# BURK-KLEINPETER, INC.

November 22, 2016

RE: Disposition of Comments from Request for Review of Application  
Dredging Improvements to Biloxi Waters  
DMR-060766 (Canaan Fishing Pier)  
DMR-060768 (Point Cadet Marina)  
DMR-140114 (Goose Point)  
DMR-140200 (Hiller Park Boat Ramp)  
DMR-170041 (Mercedes Drive)  
DMR-170043 (Holly Hills)  
DMR-170044 (Sunrise)

RE: Disposition of Comments from Request for Review of Application  
Dredging Improvements to Biloxi Waters  
DMR-140114 (Goose Point)  
DMR-170043 (Holly Hills)  
DMR-170044 (Sunrise)

## SITE D - MERCEDES DRIVE

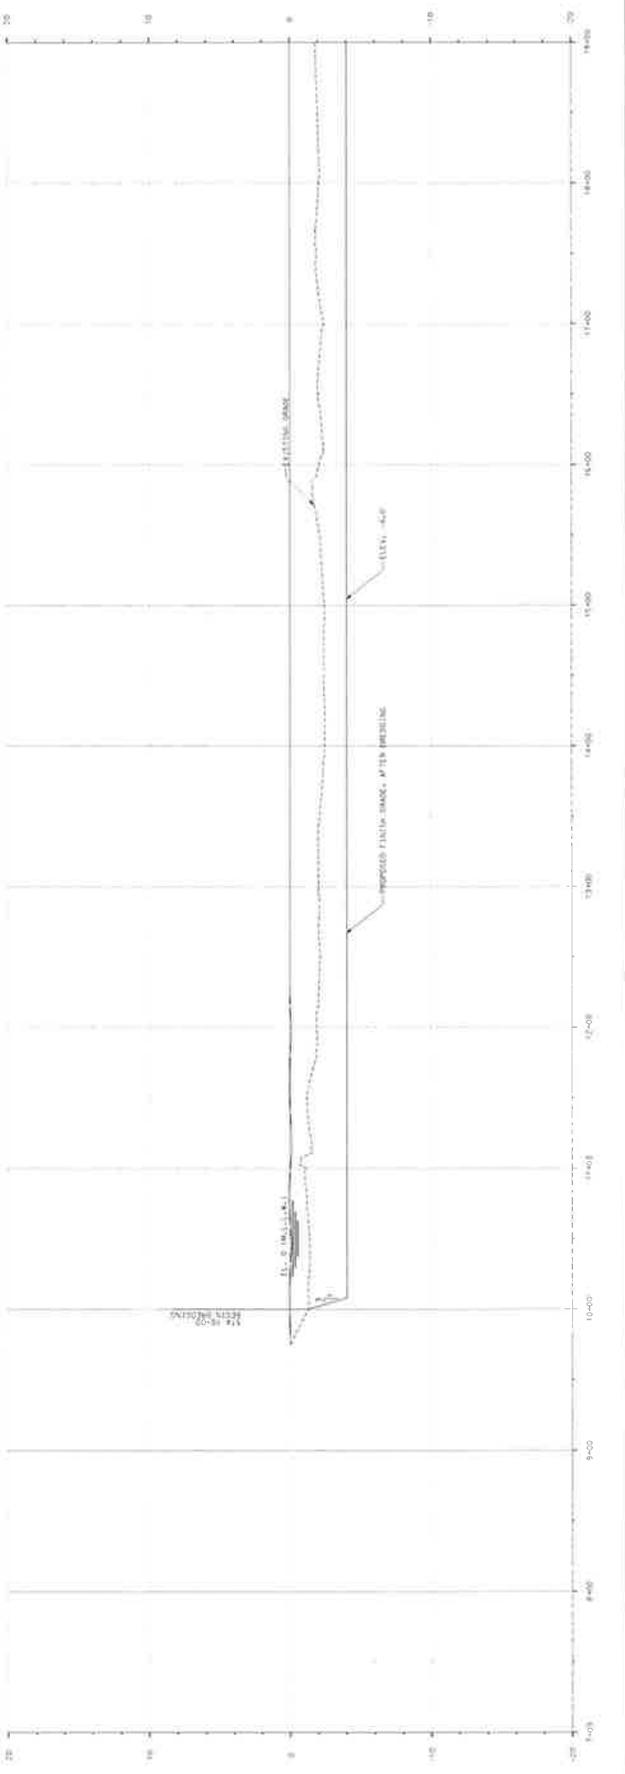
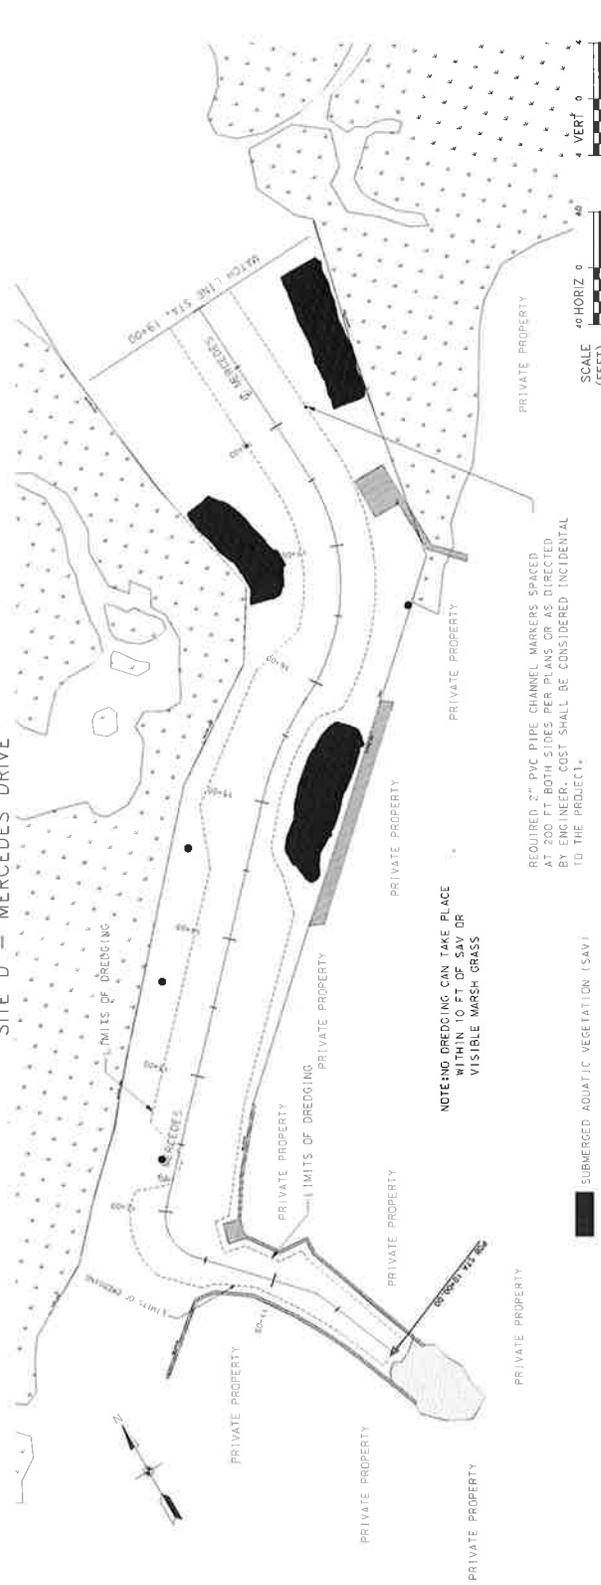
*The current plan only includes dredging within the Walda Drive Canal and along a non-critical portion of the northern end of the Main Canal. The current plan does not include dredging adjacent to the Mercedes Drive boat launch and does not include other critical areas where water is non-existent at times due to sedimentation from various sources. Waterfront property owners in the area shown on DWG-01 currently have limited access to their property by boat.*

*In order to accomplish the scope of work described in the permit application, the area shown on the attached drawing needs to be included in the subject dredging project (initial and maintenance) due to the current unnavigable depth caused by sedimentation from the main navigation channel traffic, Hurricane Katrina sedimentation, and the Christi Lane Canal runoff. We would prefer the same dredging depth and width limitations as shown on the permit drawings, for the subject project, to restore the additional dredging area to the original depth.*

- a) It is the City's intention to include these areas in a future phase contingent upon the results of additional topographic and submerged aquatic vegetation (SAV) surveys.

## SITE E - GOOSE POINT

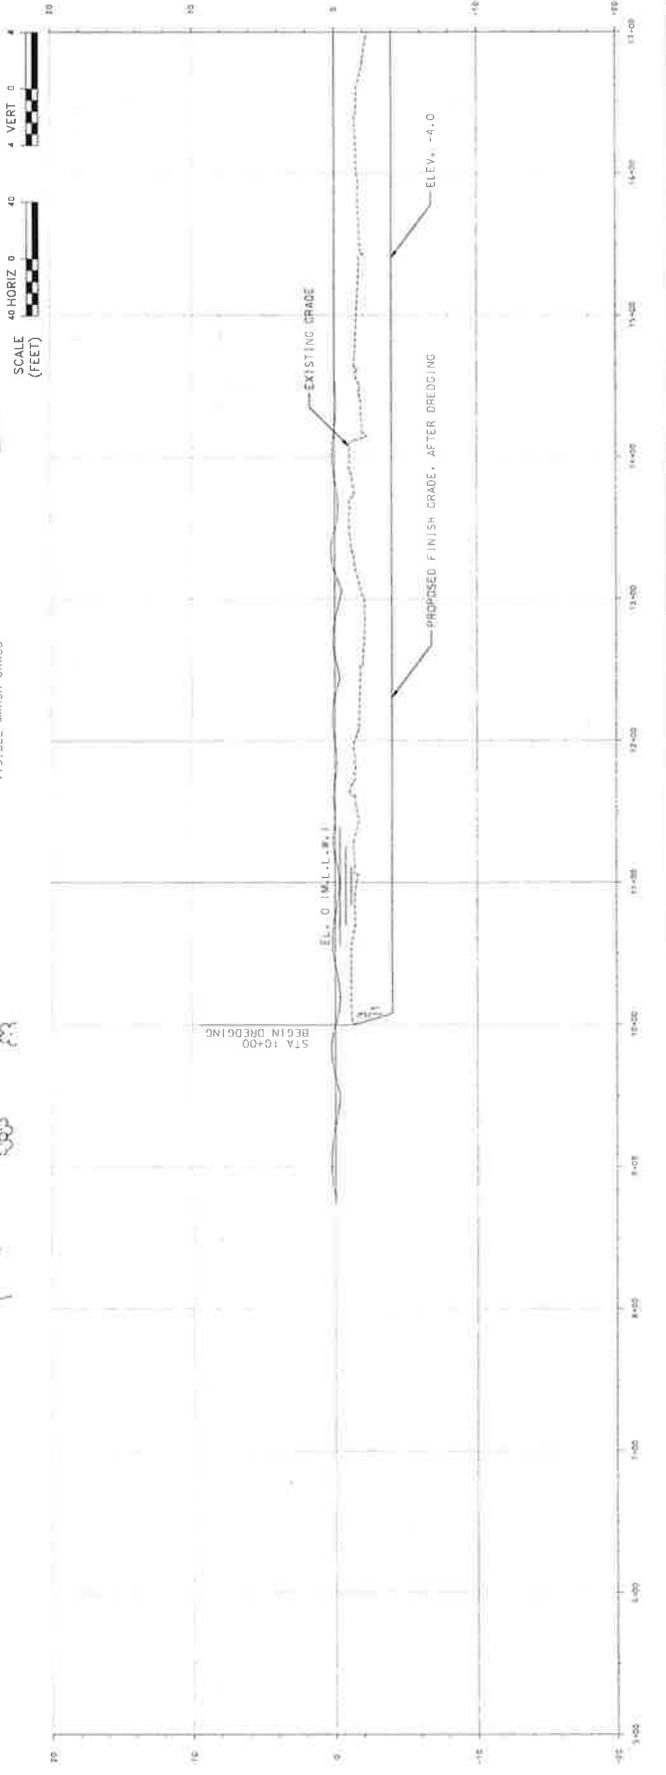
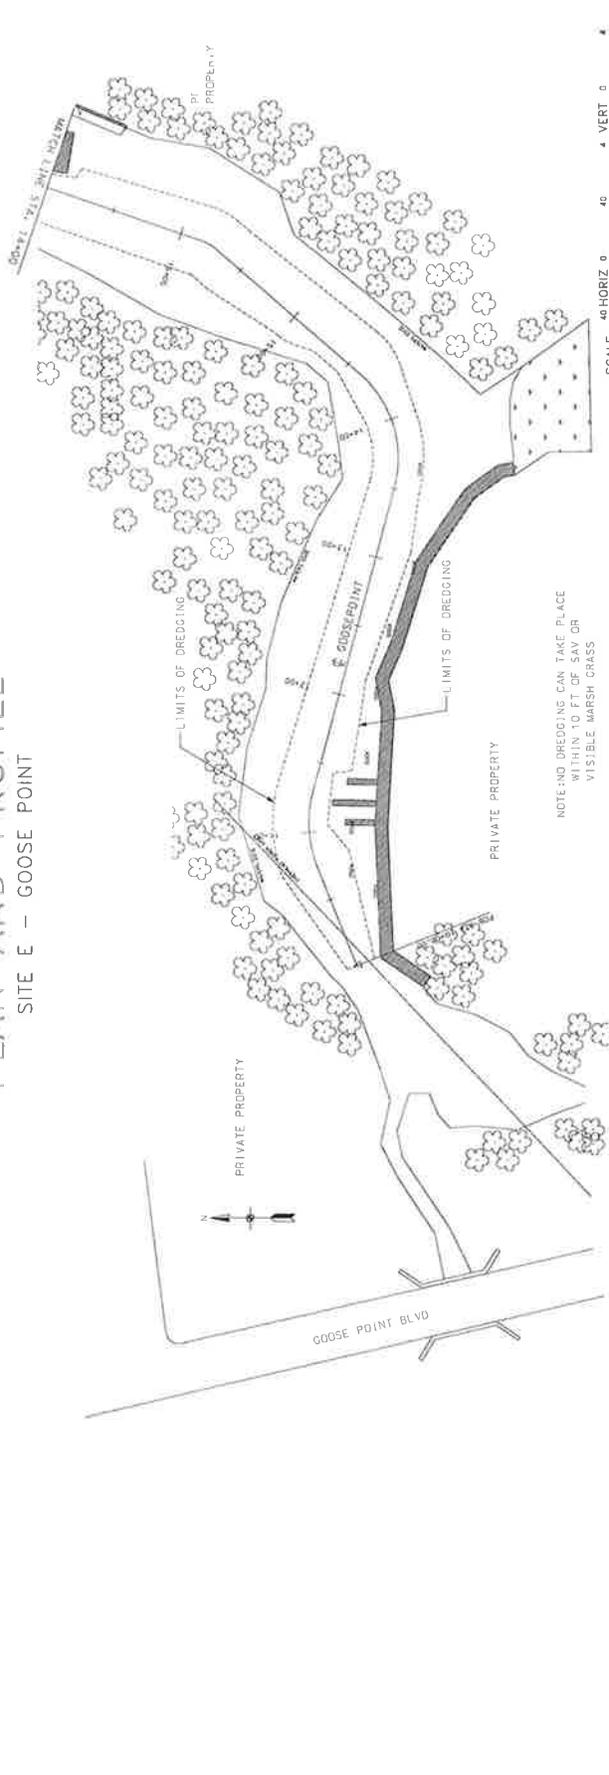
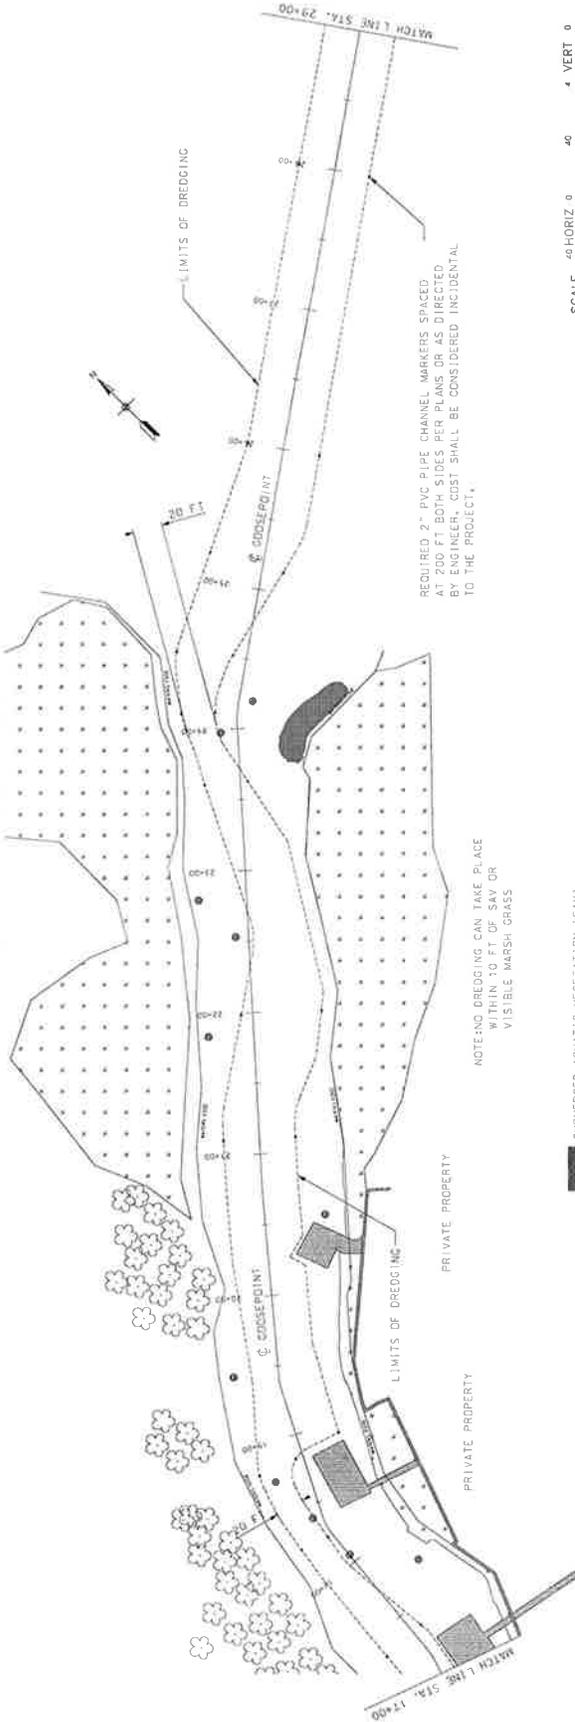
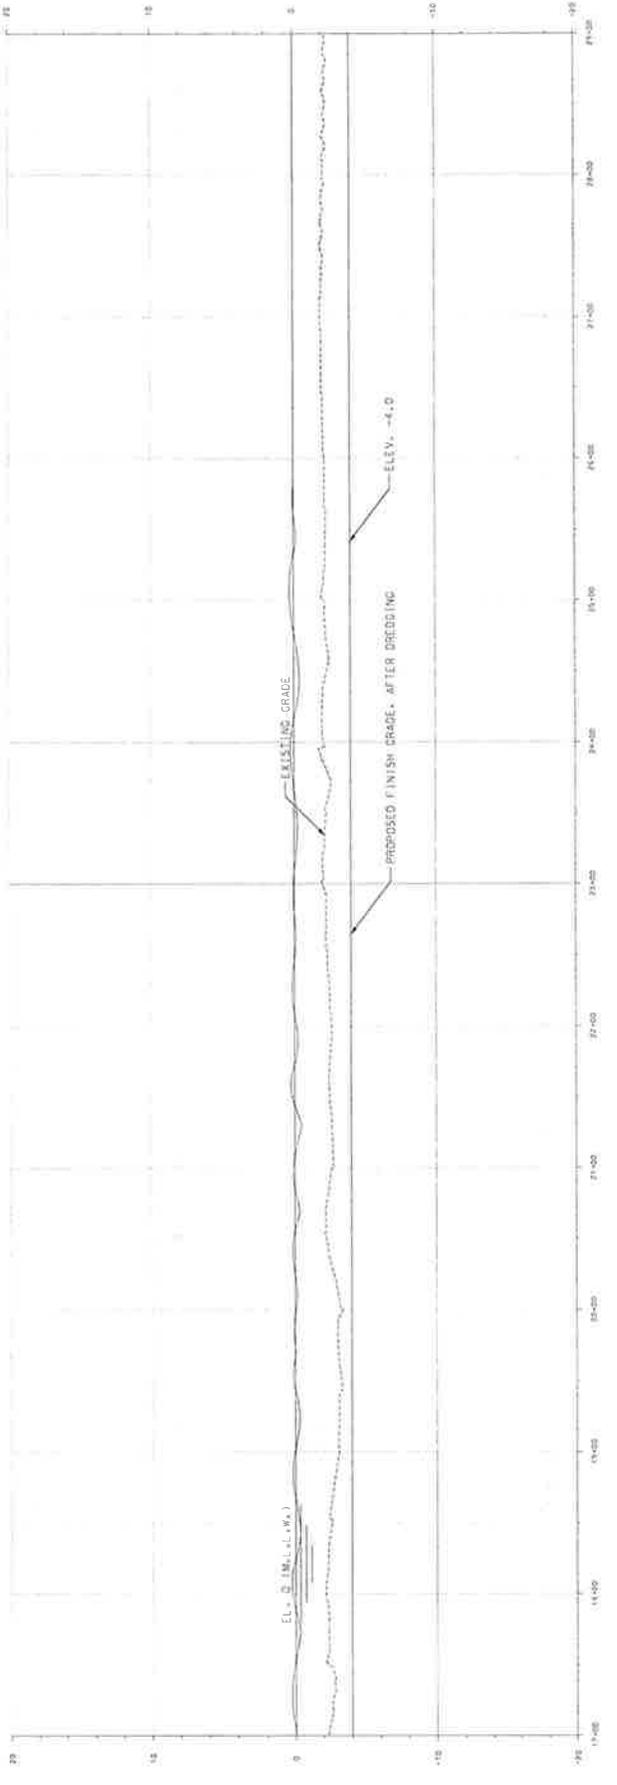
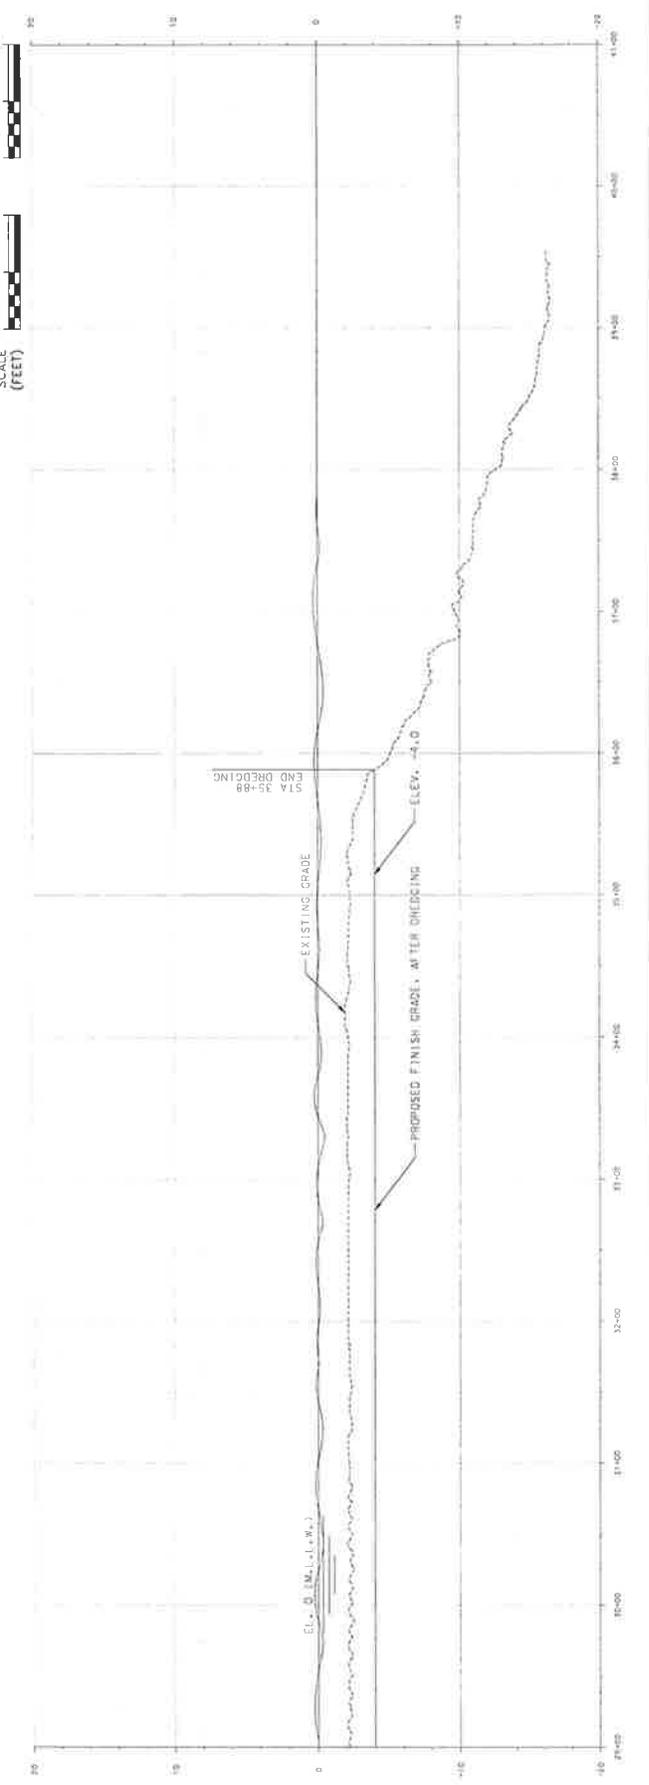
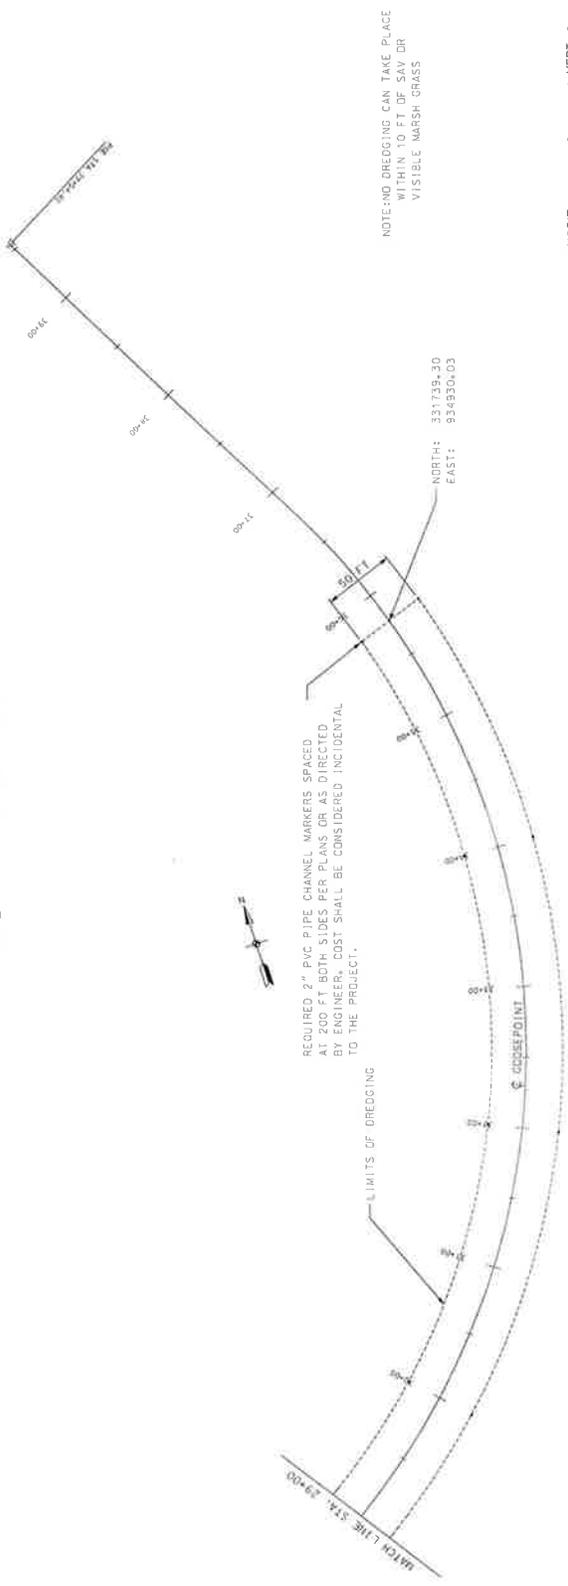
- I. PHASE E – GOOSE POINT (DMR-140114)
  - A. No public comments were submitted for this site.
  - B. Based on the information provided by Barry A. Vittor & Associates, there is submerged aquatic vegetation located within our project limits. Please see the attached revised plan and profile of the project limits. The modifications were minor and but it did reduce the estimated quantities by approximately 375 C.Y.

## SITE F - HOLLY HILLS

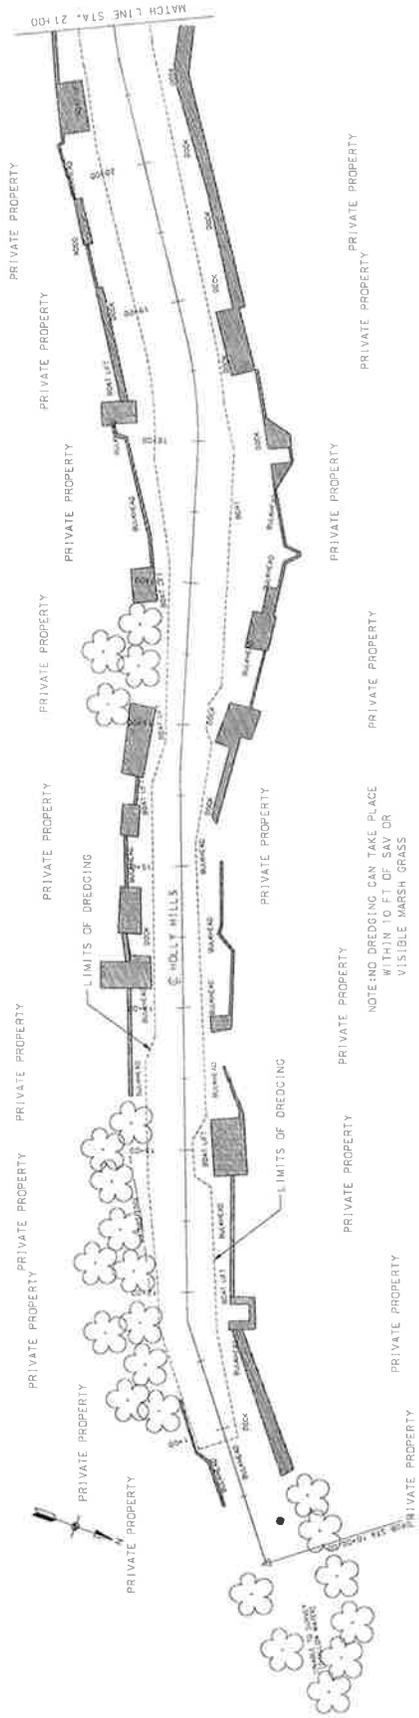
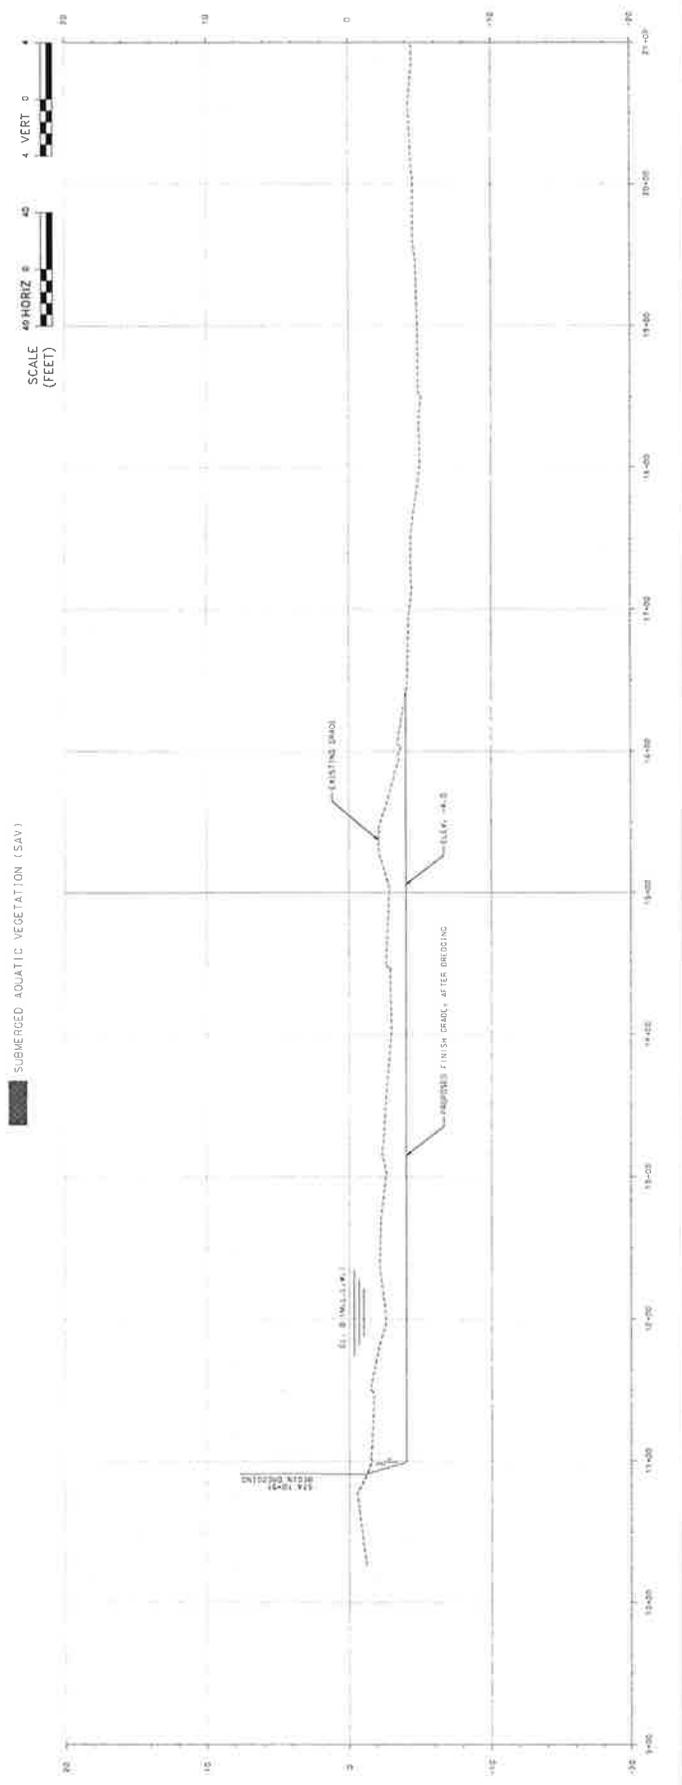
1. *I am writing about the planned dredging in our area of Biloxi. Our second home is at [REDACTED]. According to the plans and profile (Site F Holly Hills, #4) the dredging stops even before it gets to our bulkhead. We use to have plenty of water back behind our place. Our parents got a permit and had it dredged and it has filled back in from the construction and the drainage from the streets. Can you please look into this matter and help us be assured ours will be included in the dredging?*

a) DMR regulations state that we are required to provide a 10-foot buffer adjacent to all submerged aquatic vegetation (SAV) and marshes. Based on the results of the SAV Survey provided by Barry A. Vittor & Associates, Inc., there is existing SAV at STA. 10+25. Since the existing channel is not wide enough to provide this buffer, the City will be unable to extend the project limits. Please see Appendix A for a copy of the SAV Survey.
